ITEM FOR ENVIRONMENTAL BOARD AGENDA

**NAME & NUMBER
OF PROJECT:** PARMER LANE EXTENSION PHASE 1A AND OLD HWY 20
SP-06-0544D

REQUEST: Variance request to exceed the 4' cut /fill maximum limit
(25-8-341, 342).
Variance request to exceed clearing width outside the right
of way (25-8-322).

SUBJECT: Parmer Lane Extension Phase 1A and Old. Hwy 20. (SP-06-0544D)
10200 US Hwy 290

FARMER LANE EXTENSION AND DAD HIGHWAY 20
EXHIBIT FOR CUT/FILL WAIVER

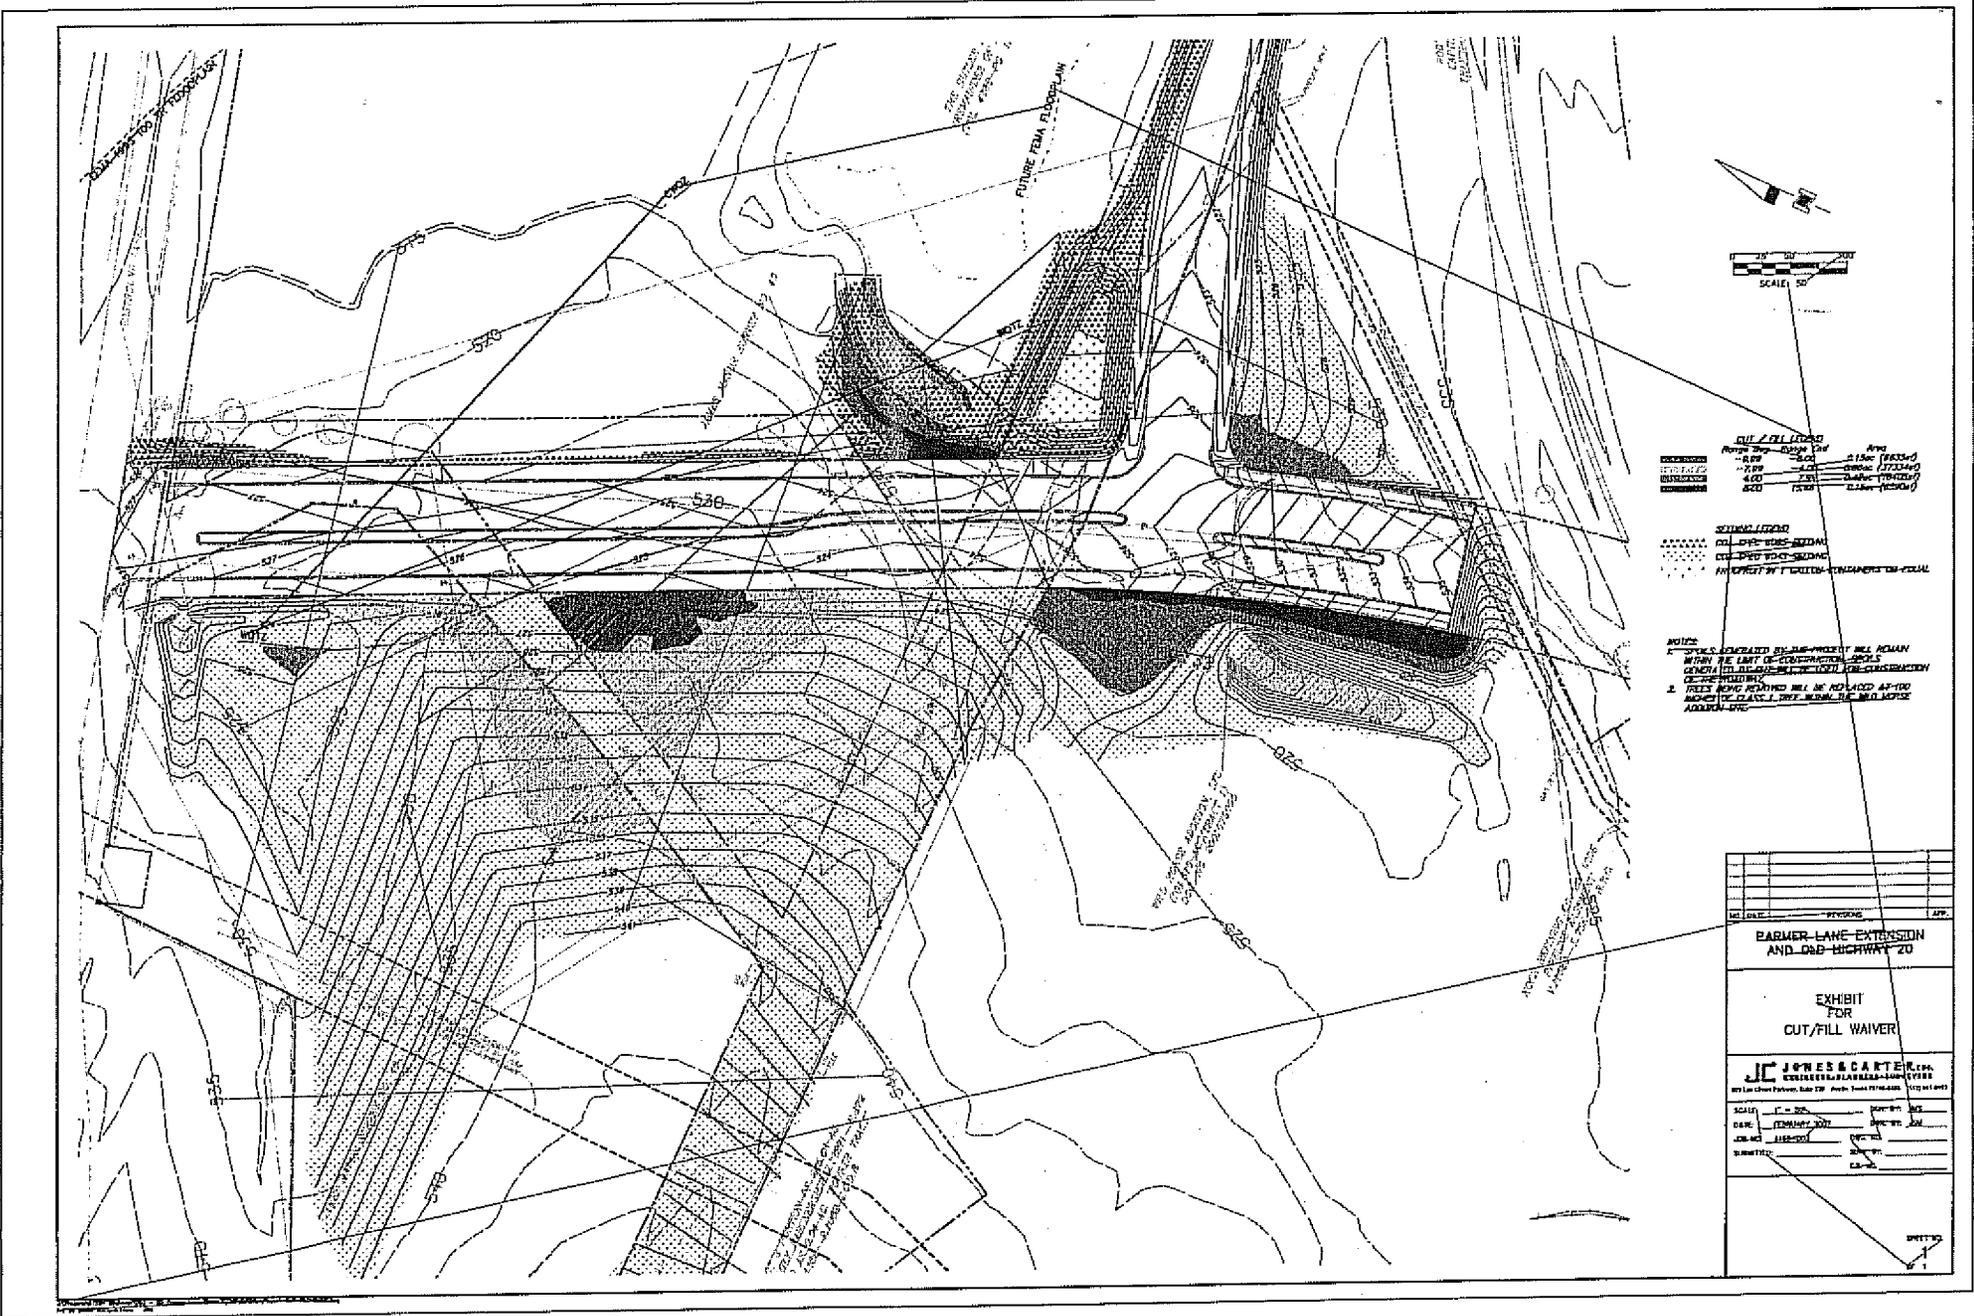
Cut is proposed to a maximum of ten (10) feet and fill is proposed to a maximum of sixteen (16) feet. This variance is required to construct the improvements in a manner that will ensure that design speed requirements and intersection elevations can be met and to provide for positive drainage patterns around the improvements.

The clearing width for the improvements is proposed to exceed the proposed right-of-way and extends to a maximum of 600 feet outside of the right-of-way. The clearing area ranges from 150 feet to 600 feet in order to transition the roadway elevation to existing grade.

- (1) The applicant will restore all disturbed areas using COA Spec 604S and 609S.
- (2) The applicant will replace all trees being removed at 100 inches of Class I trees within the Wild Horse Addition site.
- (3) No use of pesticides, herbicides, or fertilizer in Old Hwy 20 right-of-way.
- (4) The applicant will take necessary precautions to ensure that the existing gas pipelines will not be disturbed by the proposed improvements.

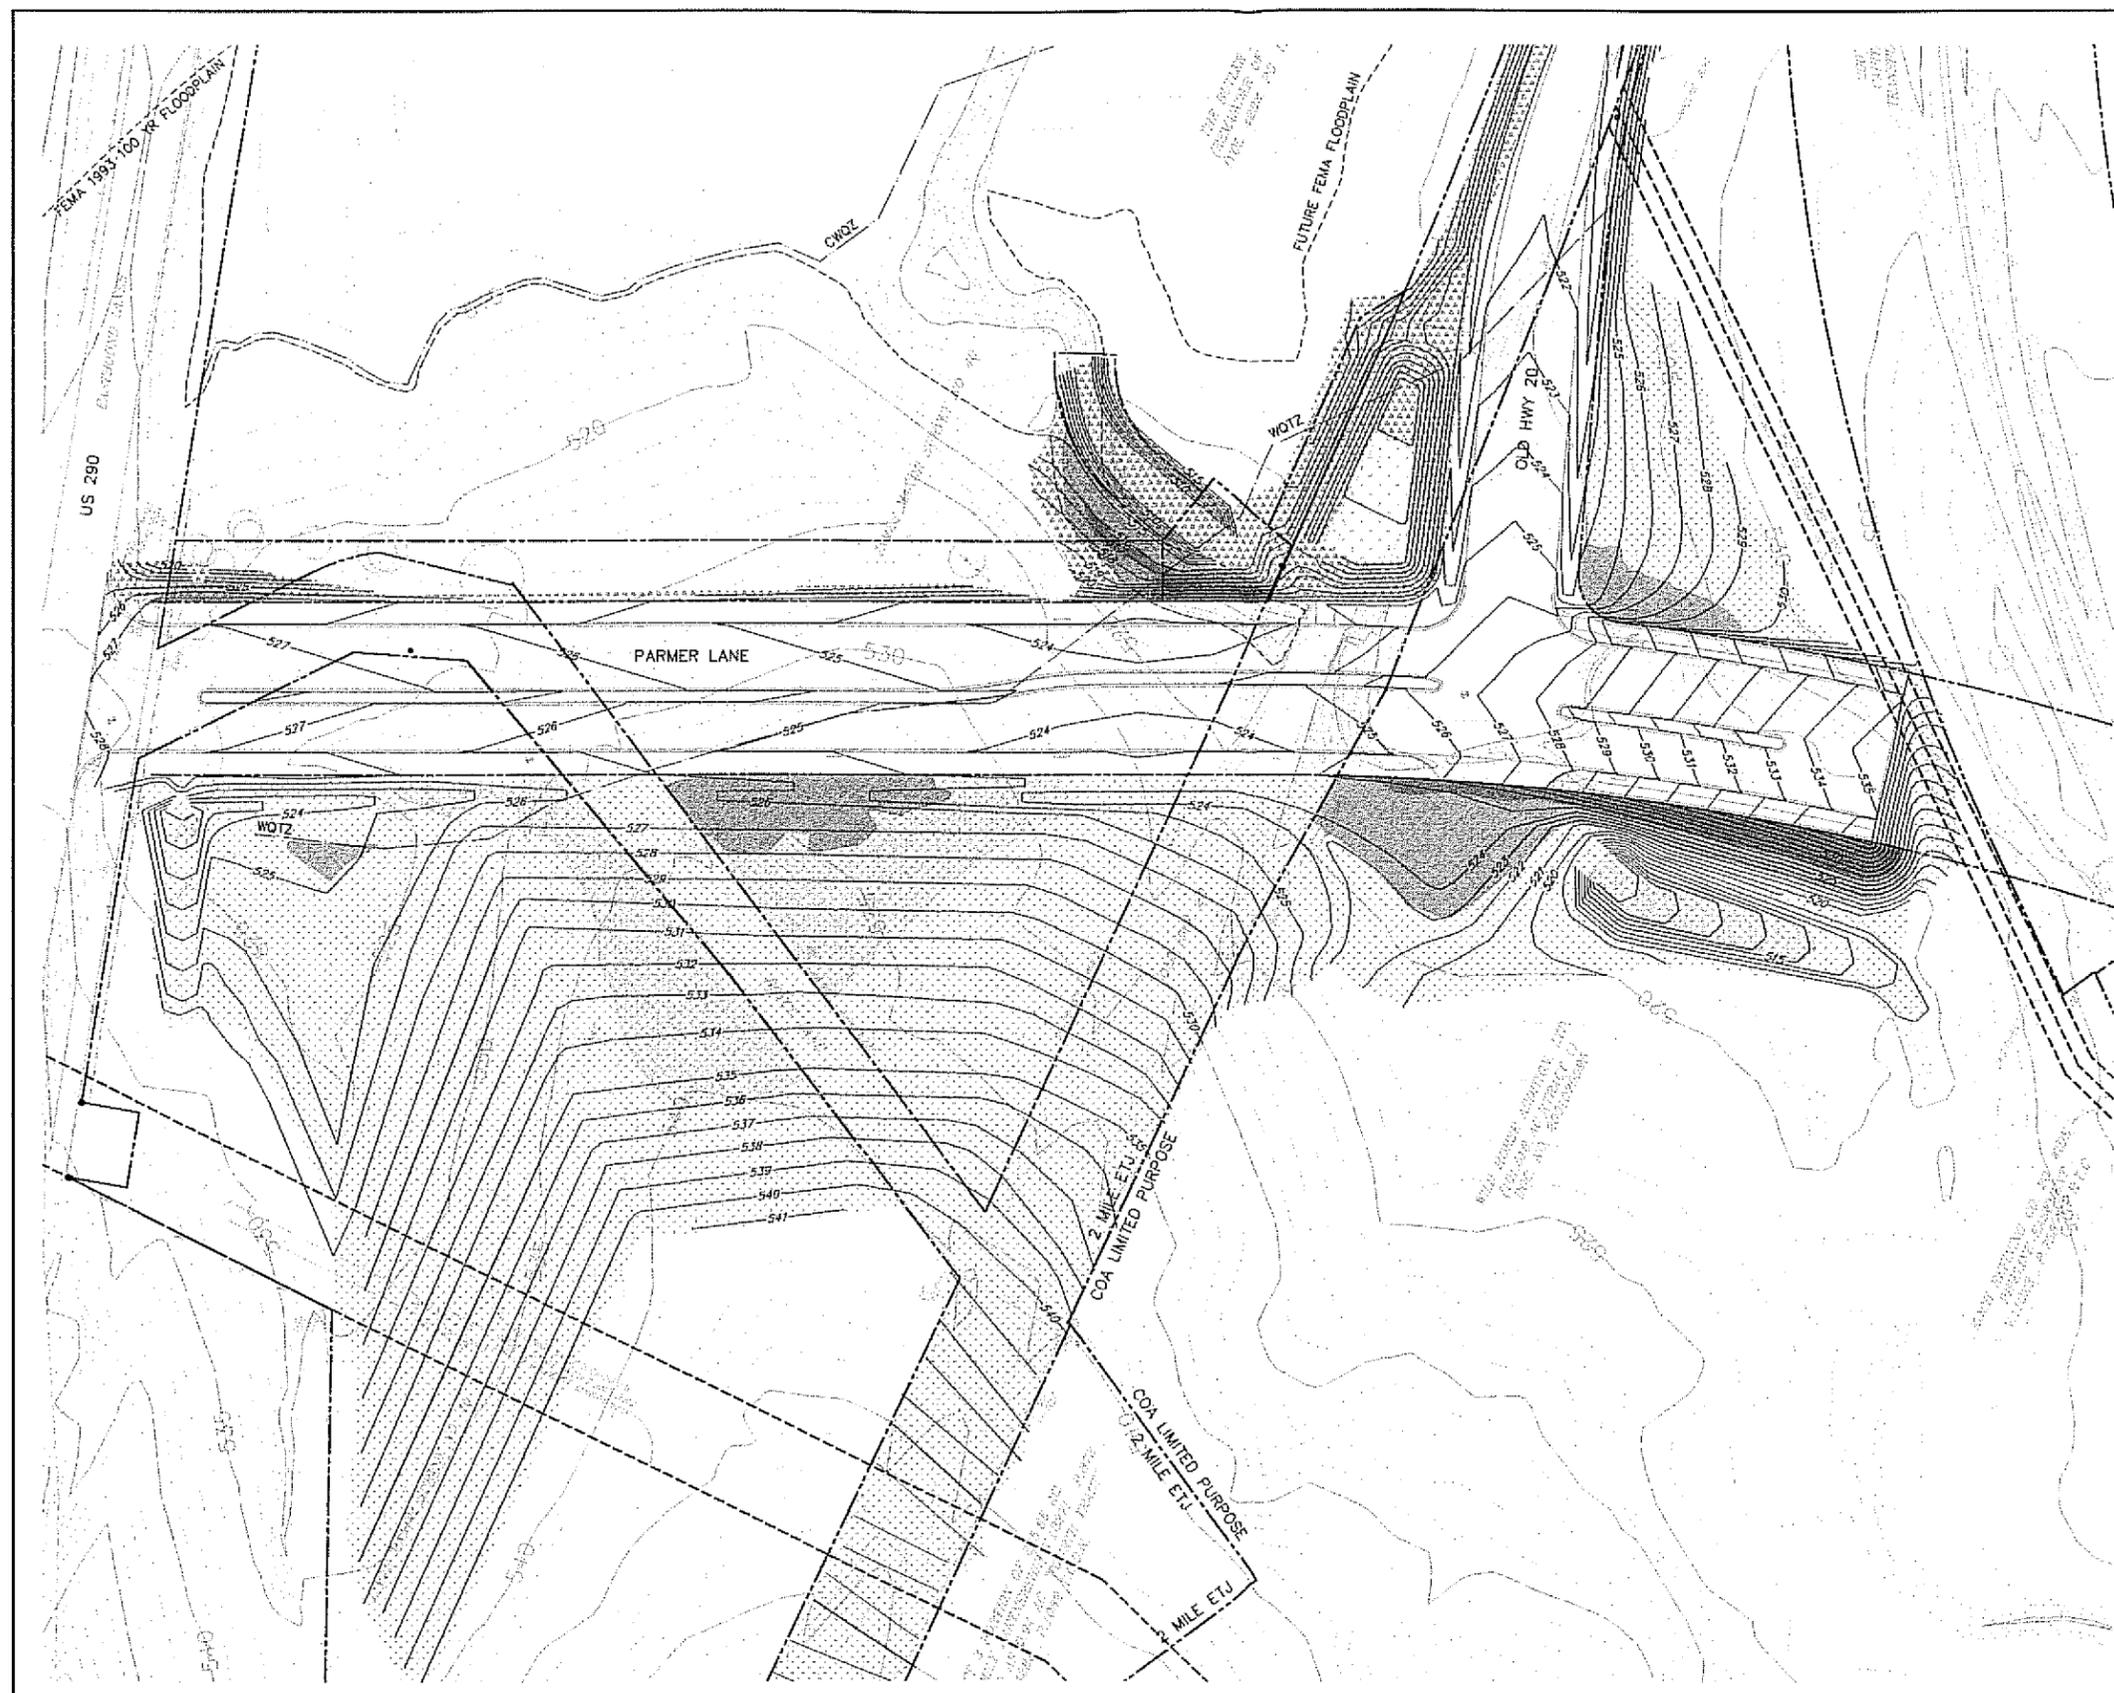
Application Name: Parmer Lane Extension Phase 1A and Old Hwy 20
Application Case No: SP-06-0544D
Code Reference: Land Development Code Section 25-8-341 Cut Requirements & Section 25-8-342 Fill Requirements
Variance Request: To allow a cut of ten (10) ft & allow a fill of sixteen (16) ft for roadway construction.

Yes. The extent of the cut has been reduced by 2' from the original proposal.

1. The Applicant will restore all disturbed areas using City of Austin Spec 604S and 609S.
2. The Applicant will replace all trees being removed at 100 inches of Class 1 trees within the Wild Horse Addition site.
3. The Applicant will not use pesticides, herbicides, or fertilizer in the Old Highway 20 right-of-way.
4. The Applicant will take necessary precautions to ensure that the existing gas pipelines will not be disturbed by the proposed improvements.
